Berkeley Heights Environmental Commission

MEMO

June 19, 2023

Subject: **Connell North Grove and West Sports Courts: Block 4301, Lots 1.03, 1.04, 1.05, & 1.012**

Drawing from L401 Tree Planting Plant from MVVA Plans

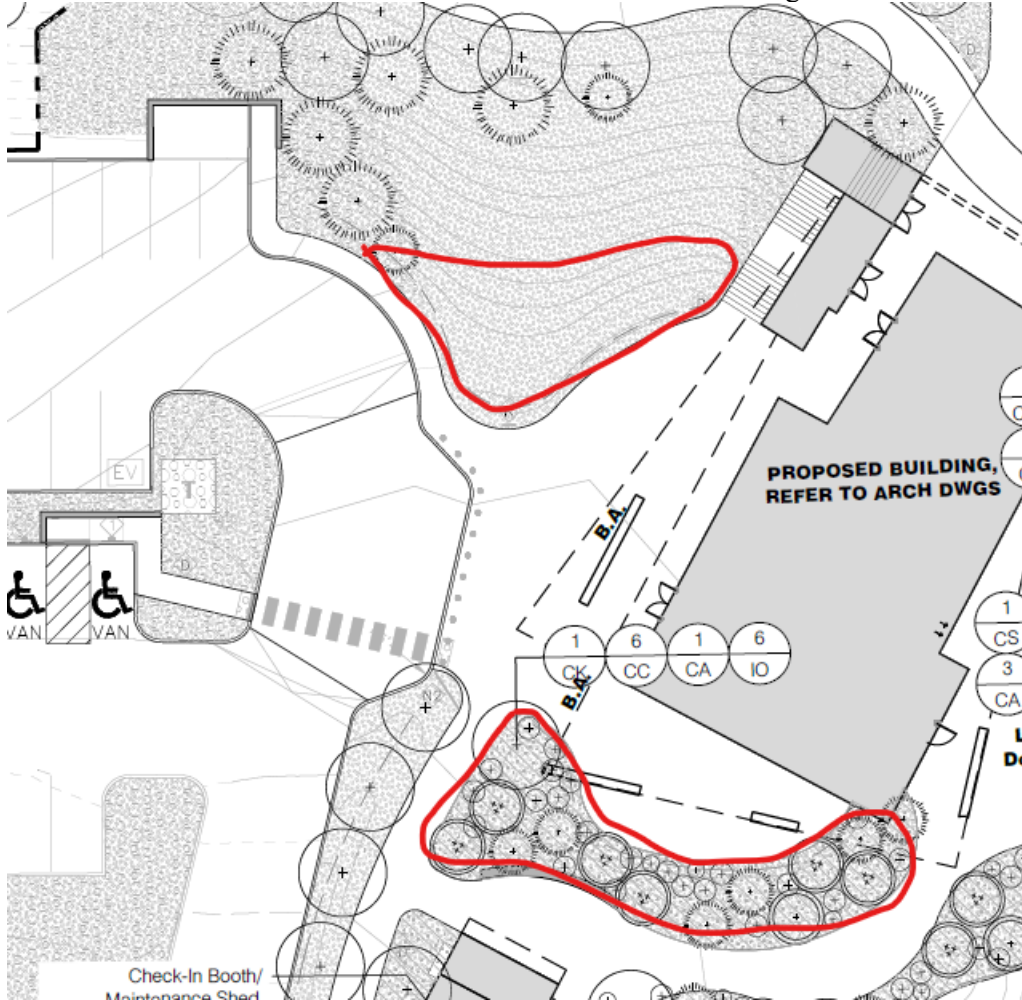
- The Rutgers Green Infrastructure Guidance Manual is available at [Water Resources Program at Rutgers NJAES](#)
- The Commission also recommends the applicant consider a Pervious Paving System for some areas.
- The applicant might also consider a large cistern to collect stormwater runoff and use it to irrigate the landscape plantings.
- *Symphoricarpos orbiculatus*, coralberry, and *Rhus aromatica* 'Gro-low' are listed under Ground cover M2. These plants would seem to be suitable for the north slope between the highway and the walking path. Please consider them for this area.
- The Commission recommends the areas circled in the drawing below for additional bioretention.
